Service Bulletin #2003-139

Applicability: All Riblet Chairlifts.

Subject: Chair Clearance Issues.

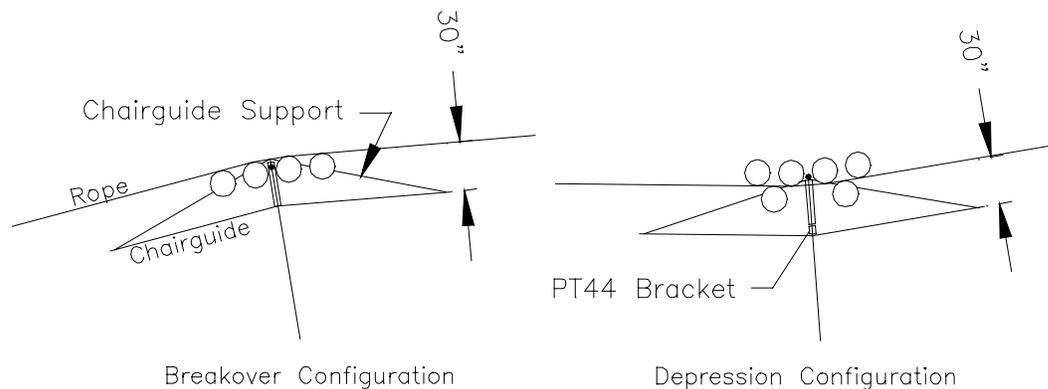
The tower chairguides on those Riblet chairlifts so equipped are designed to be approximately 30 inches below the level of the haul rope, and to be parallel to the rope. Chairguides must be bent at the center, if required, and adjusted to parallel the rope by adjusting the length of the chairguide supports on the uphill and downhill sides of the tower.

Chairlifts built prior to 1965 (and any pre-1965 towers which may have been transplanted to newer lifts) incorporate chairguide mounts which are adjustable in height. 1965-model and later chairlifts use a crossarm which mounts the chairguide at a fixed distance below the rope. When depression assemblies (CC, KK, RC, CRC, RK) are installed on these towers, a depression chairguide bracket (Riblet part no. PT-44) must be used.

describing proper installation and adjustment of the tower chairguides. Please refer to those drawings, and, as a reminder, to the sketch below, which illustrates the proper installation and adjustment of chairguides on 1965 and later Riblet chairlifts using chairguides. Pre-1965 lifts are similar, but the adjustable chairguide mounts on these lifts obviate the need for the depression chairguide bracket.

We remind you to, as part of your regular maintenance program, inspect the chairguides on each tower of all Riblet lifts equipped with chairguides to be certain that they are properly installed and adjusted.
